V2500-A5/D5 SERIES PROPULSION SYSTEMS SERVICE BULLETIN

This document transmits the Initial Issue of Service Bulletin V2500-ENG-72-0581 and the Initial Issue of the Supplement.

INFORMATION – ENGINE – PROVIDE A NEW NO. 3 BEARING OPTION**1. Planning Information****A. Effectivity****(1) Airbus A319**

ENGINE - NO. 3 BEARING OPTION
72-32-24
FIGURE 1

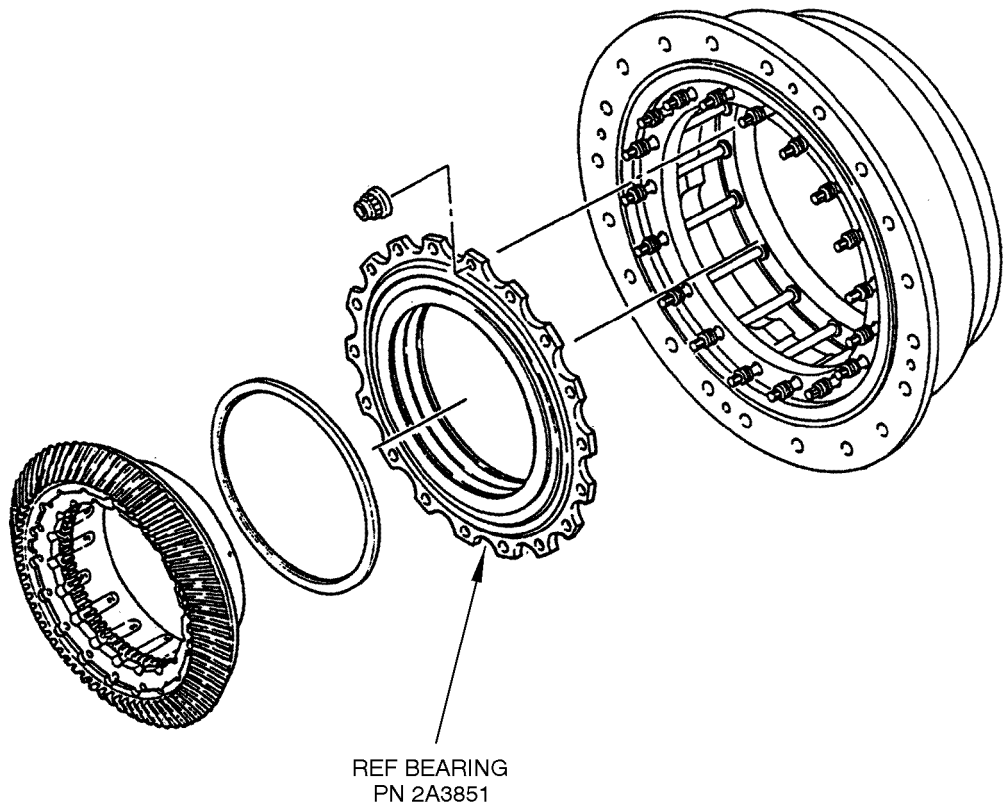
Introduce new No. 3 Bearing Option, P/N 2A4235, which includes the current M50-NiL SKF Bearing P/N 2A3851 and FAG-C M50-NiL Bearing P/N 2A4170.

Provide a new No. 3 Bearing Option, P/N 2A4235, which includes the current M50-NiL SKF Bearing P/N 2A3851 and FAG-C M50-NiL Bearing P/N 2A4170.

(01) No. 3 Bearing Option, P/N 2A4235, consists of a No. 3 Bearing, P/N 2A4170 or P/N 2A3851.
